Hellwig Helper Springs Adjustment

Bulletin Type:	SRP	Publication Date:	August 2026
Bulletin #(s):	26-021	Make(s):	Jayco & Entegra Coach
Job Code(s):	<i>**If affected unit has a warranty remaining, submit your claim following the normal process.</i>	Model(s):	Redhawk, Greyhawk, Odyssey
Flat Rate(s):		Model Year(s):	2026 - 2027

Incident:	Hellwig Helper Spring U-bolt is causing unusual noise.
Affected Units:	Certain 2026 - 2027 Jayco Greyhawk & Redhawk & Certain 2026 - 2027 Entegra Coach Odyssey
Parts Kit: N/A	Parts Kit #: N/A
	N/A
Misc. Tools & Supplies:	Pry Bar Tube or Wood
Parts Return Information:	N/A

Fig. 1

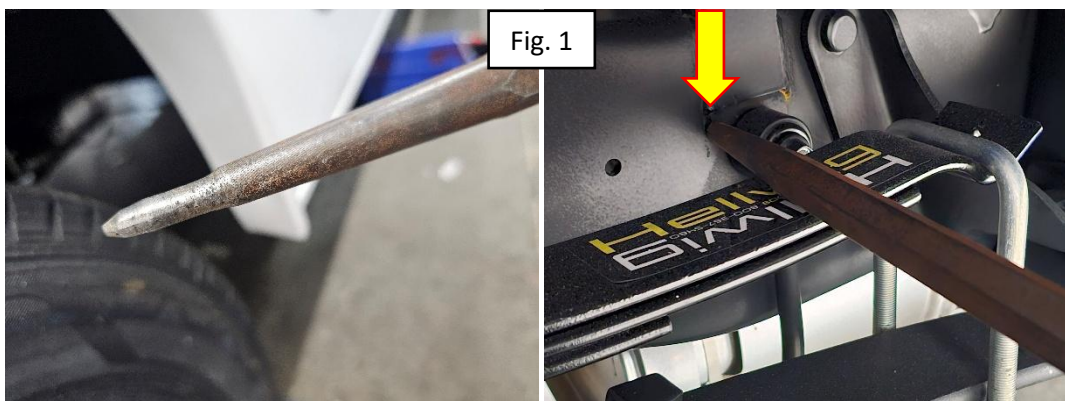
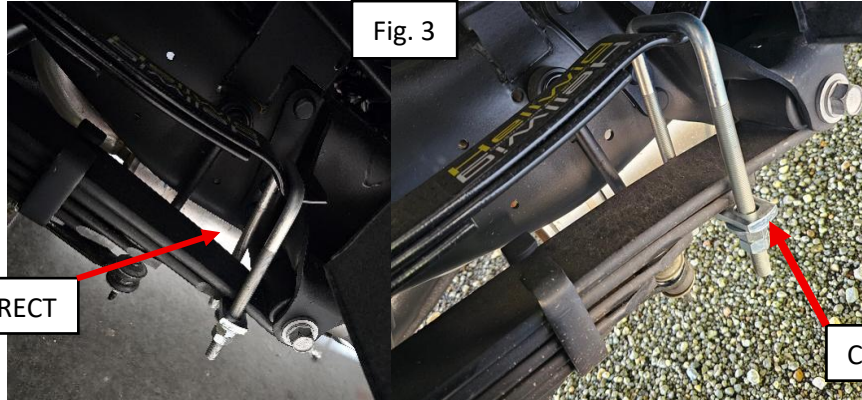
1. Locate the U-Bolt and leaf springs at the rear axle of the coach.
2. Use a pry bar or metal bar with a sharpened point, insert it in the hole in the chassis frame rail next to the sway bar link and U-bolt, above the helper spring. (Figure 1)
